2022 Draft Final Blacktail Creek Groundwater Hydraulic Control System Remedial Design Work Plan

RE: Draft Final Blacktail Creek Groundwater Hydraulic Control System (BTC GWHC) Remedial Design Work Plan (RDWP)

**Response to Agency Comments to the
Butte Priority Soils Operable Unit (BPSOU) Draft Blacktail Groundwater Hydraulic Control
System Remedial Design Work Plan**

Date of Comments: September 29, 2022

FIGURE 5 Draft BTC GHCS RD/RA Project Schedule
 Project: Blacktail Creek (BTC) Groundwater Hydraulic Control System (GHCS)
 Date: Fri 11/18/22

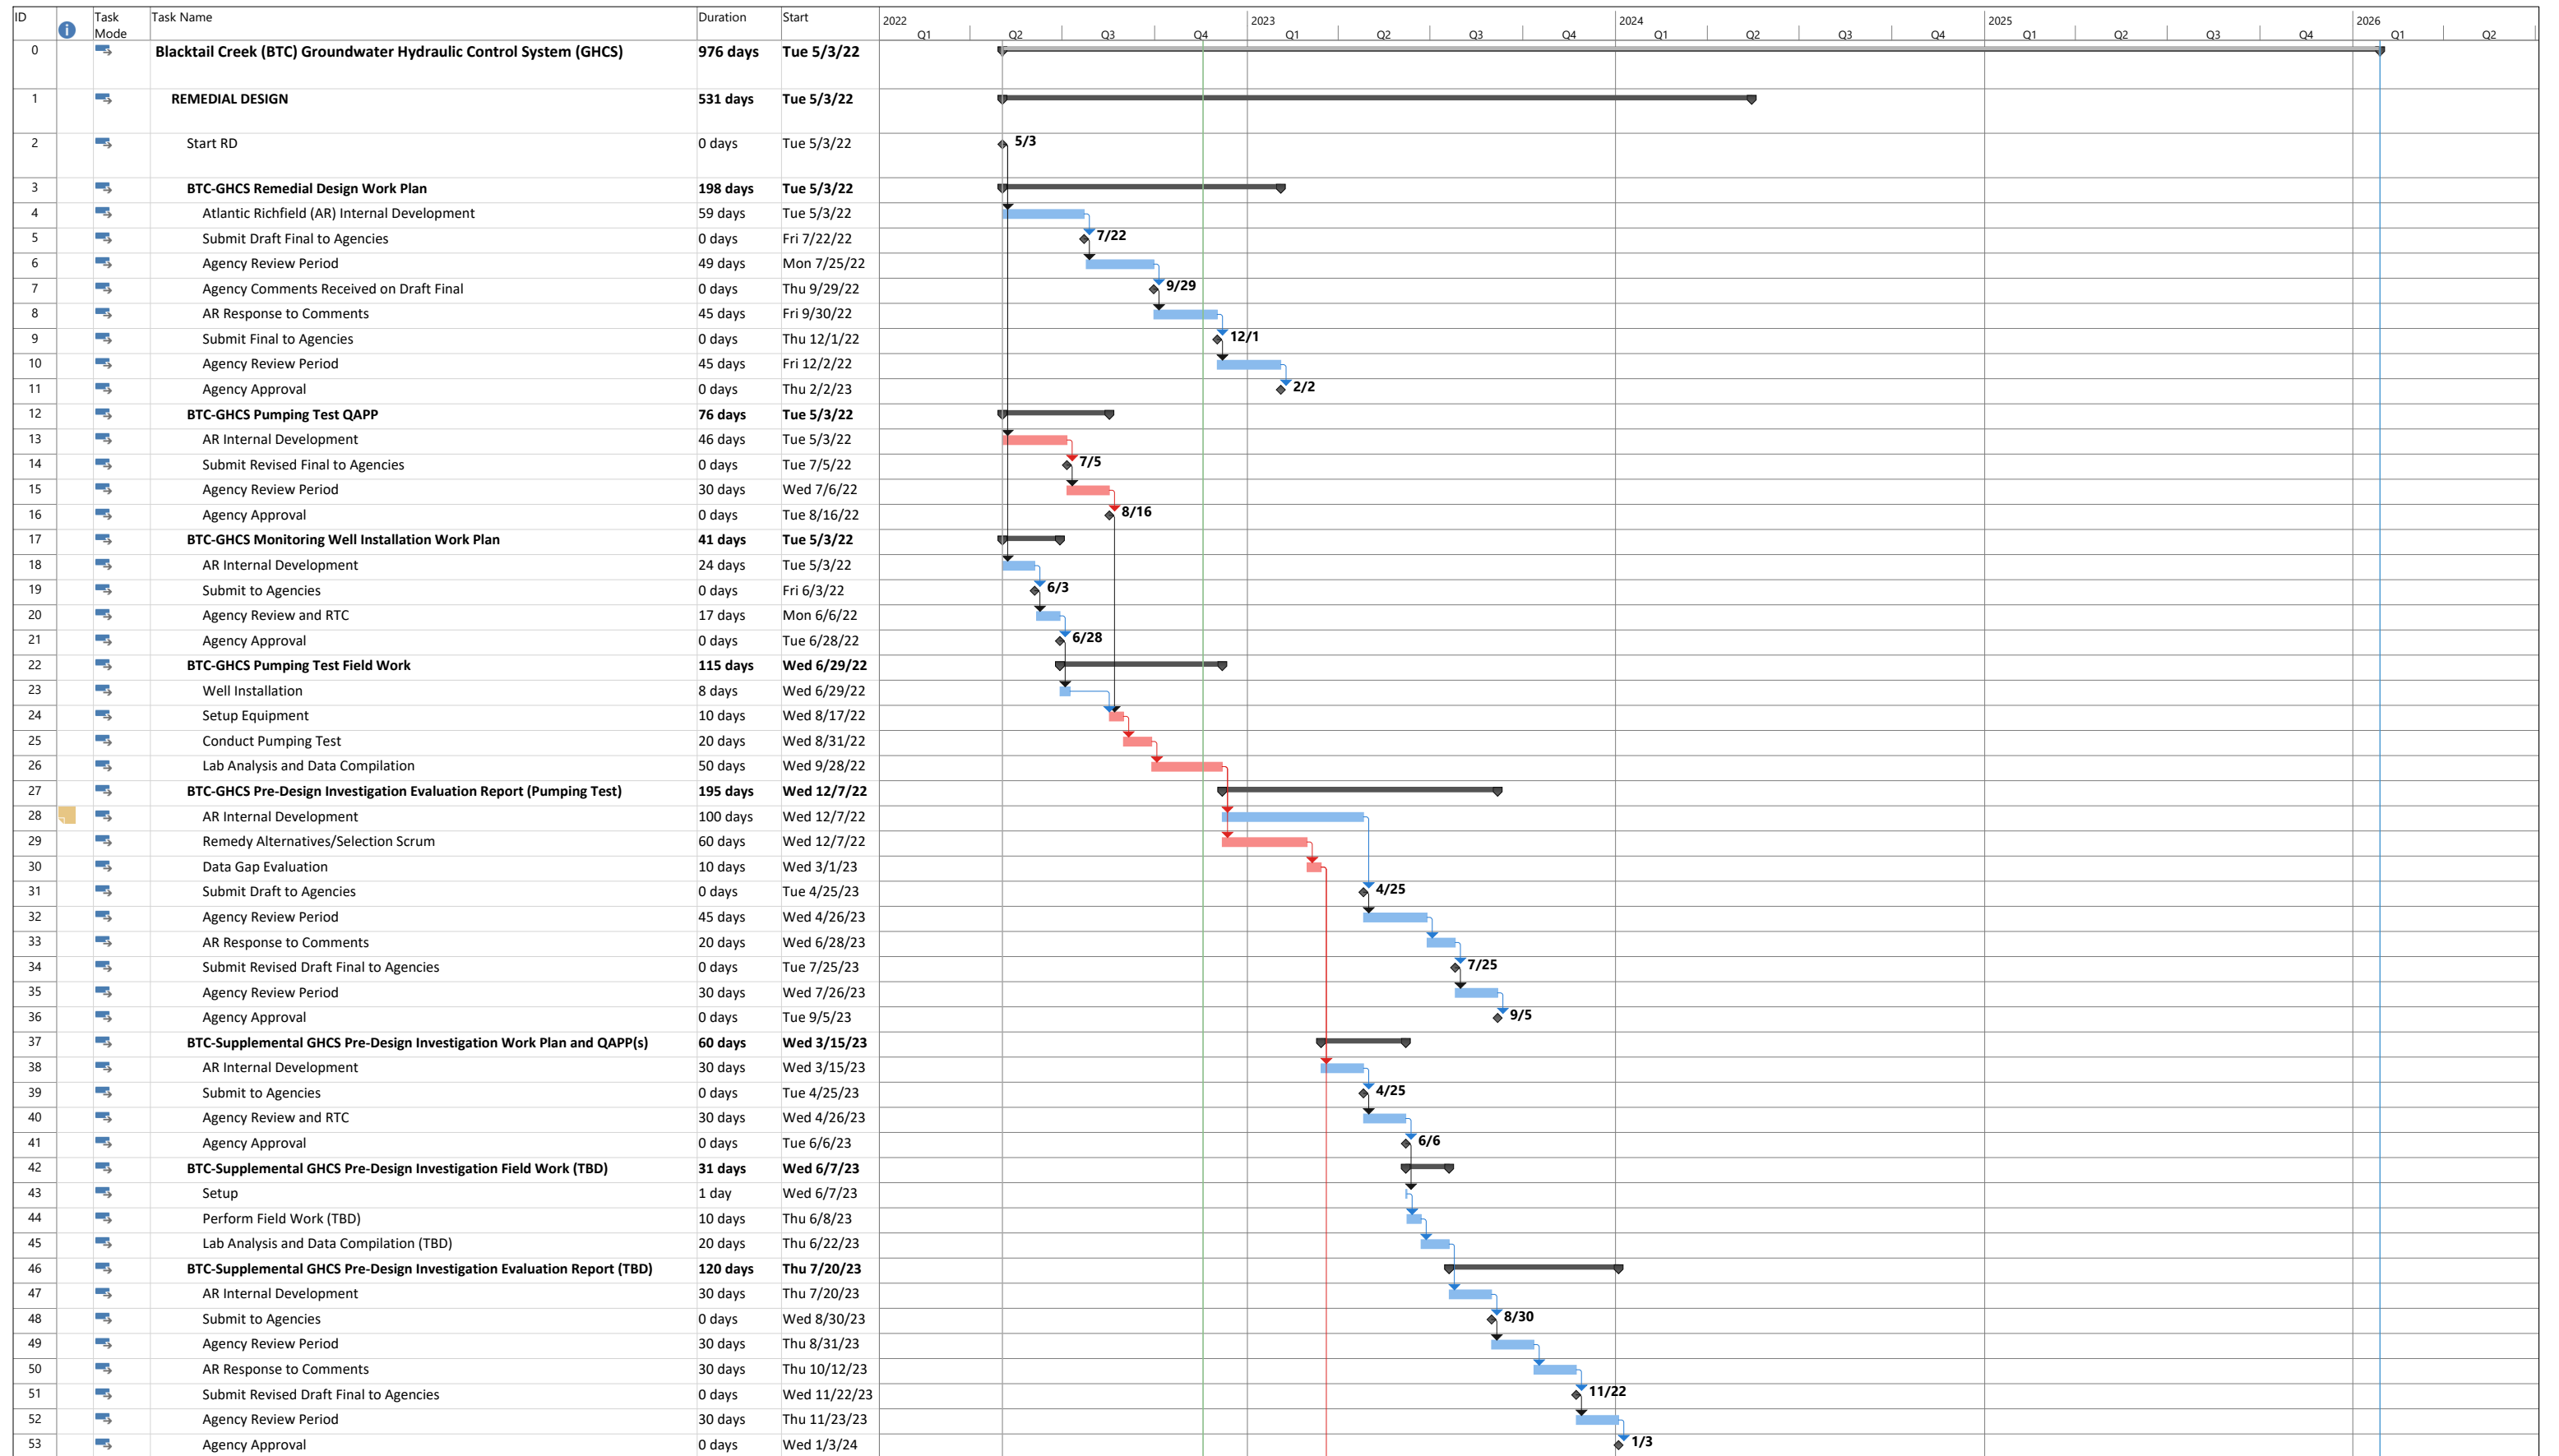
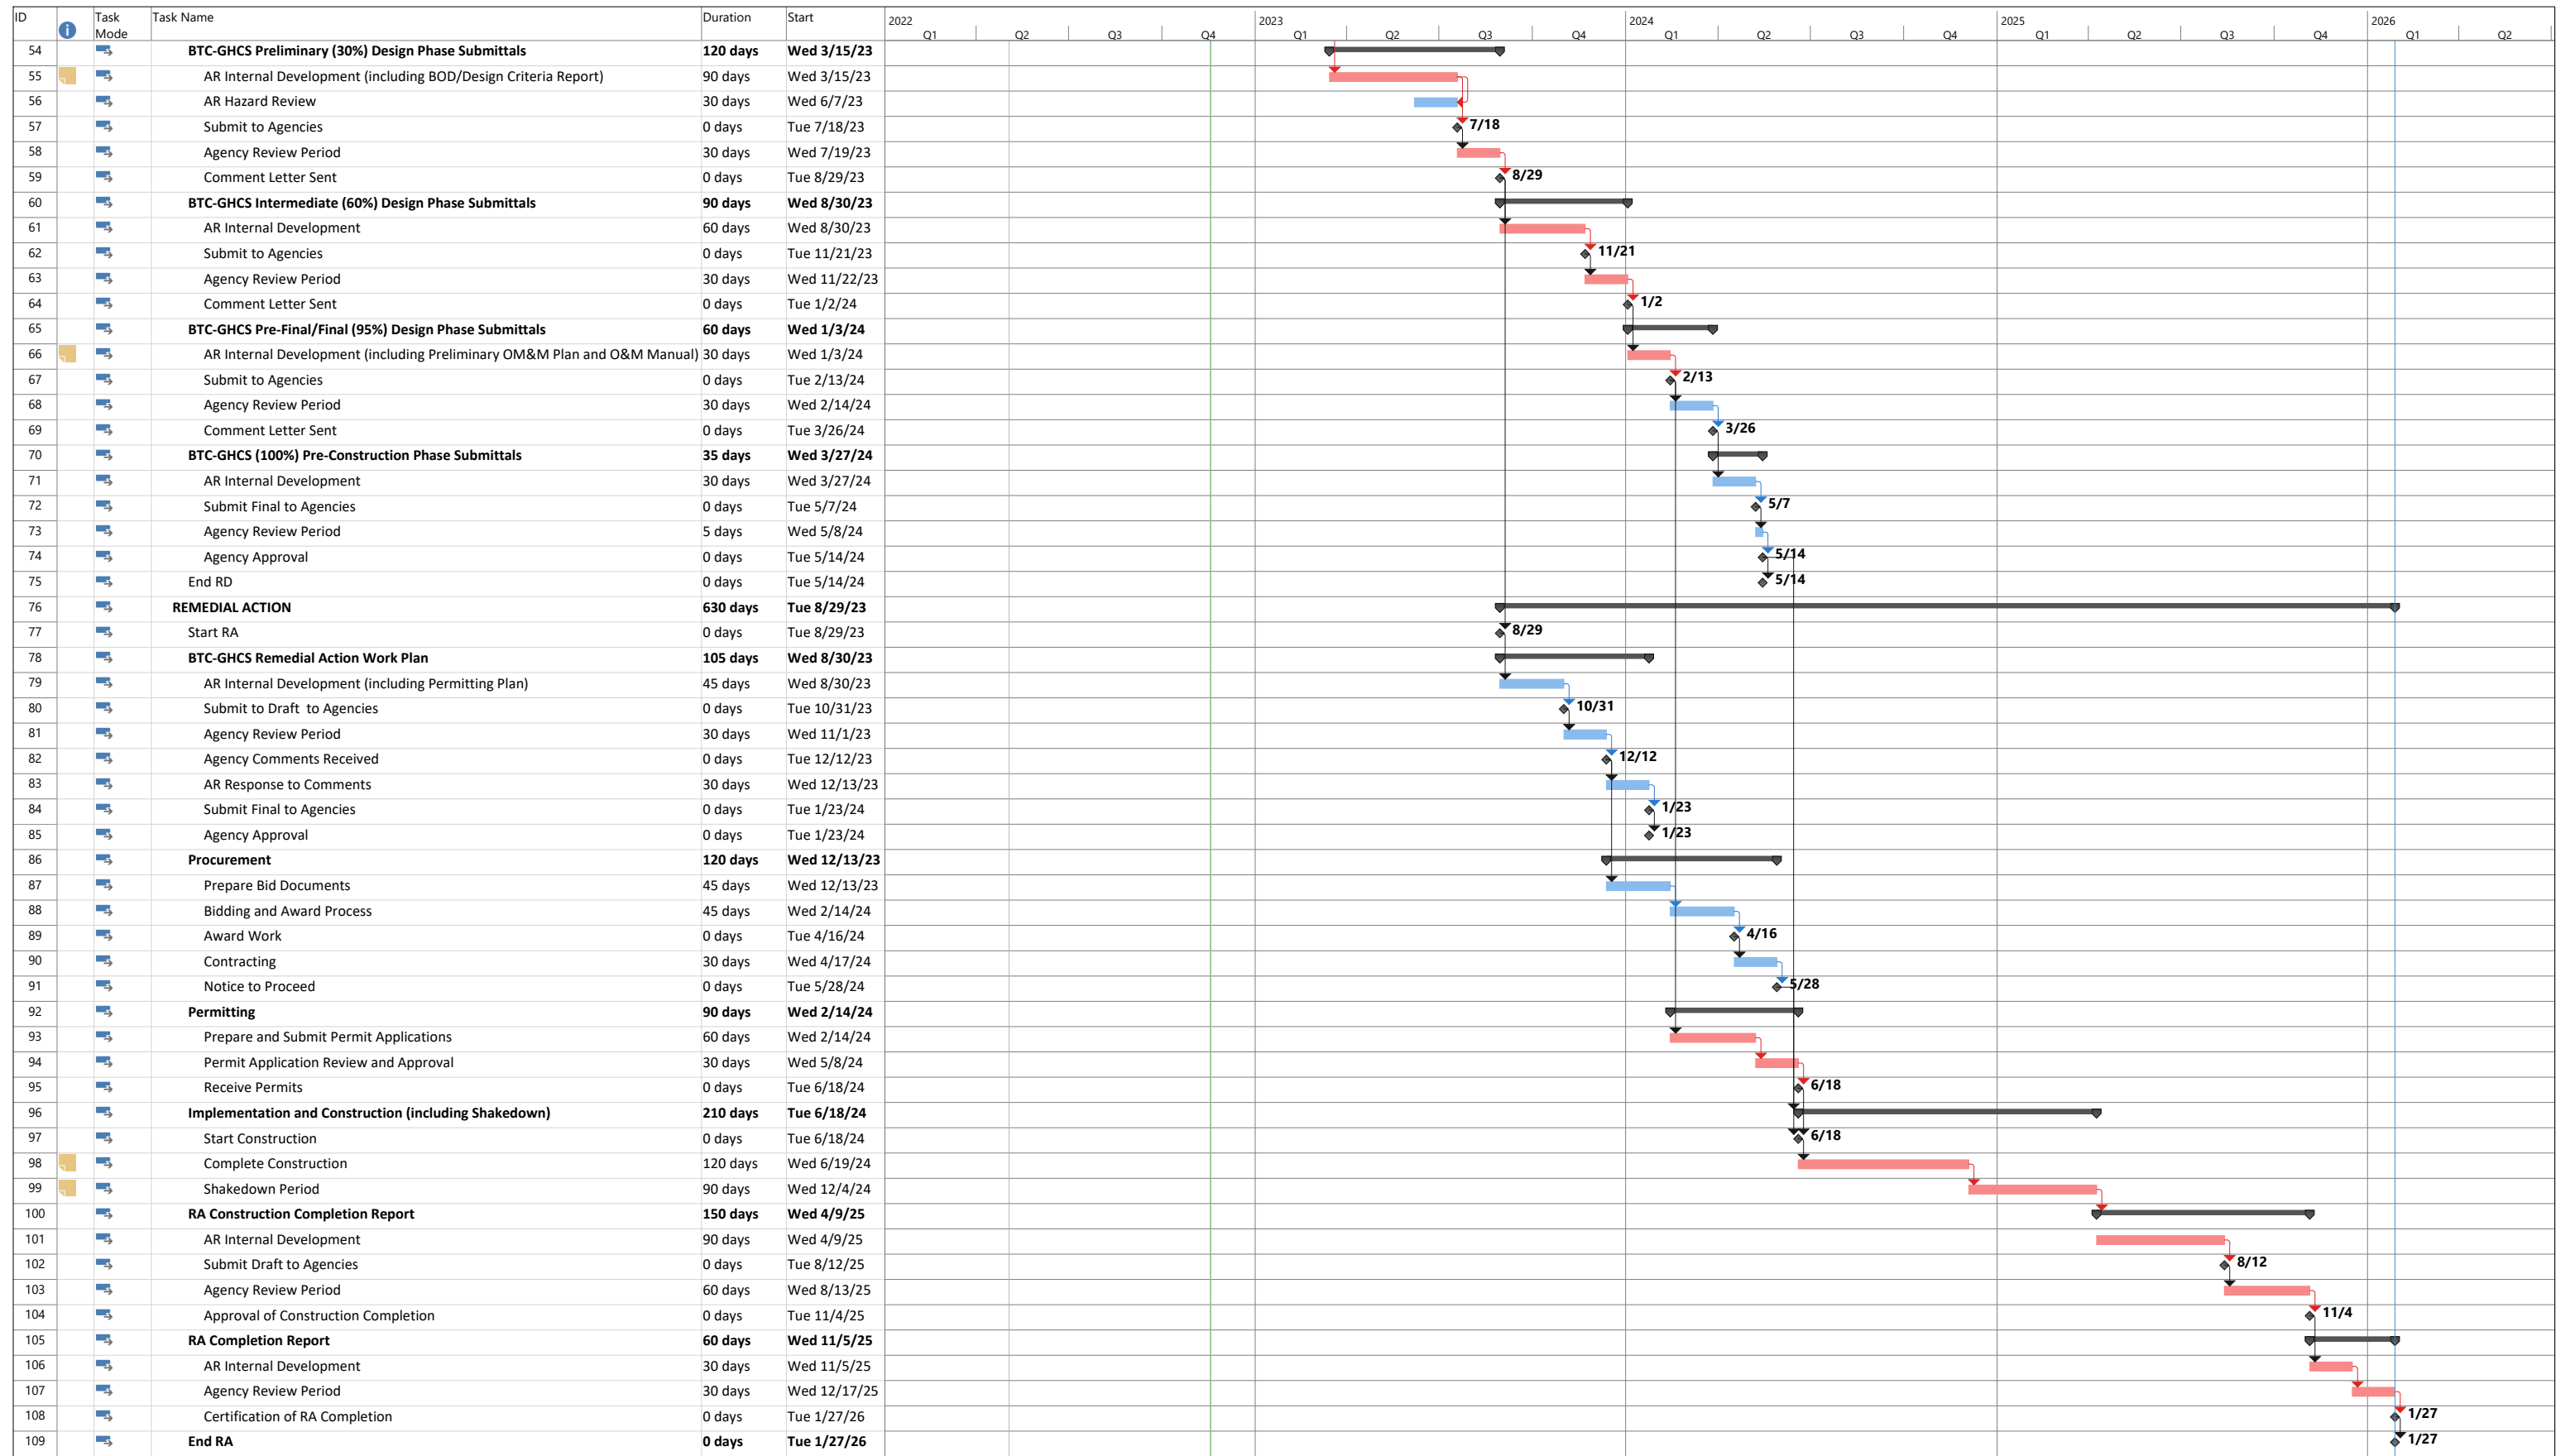
EPA Specific Comment 2c (Figures): Please consider moving the Schedule up to the Figures section so that it's not buried at the back of the document.

EPA Specific Comment 25 (Appendix B – Draft BTC GHCS RD/RA Project Schedule):
Acronyms at the top of the project schedule (Appendix B) are incorrect. GCS should be changed to GHCS for Groundwater Hydraulic Control System and the acronym “AR” is undefined.

Atlantic Richfield Company Response: The Schedule has been relabeled as Figure 5 and added to the Figures section. Figure and Appendix references have been updated.

Atlantic Richfield Company Response: Edits have been made as requested.
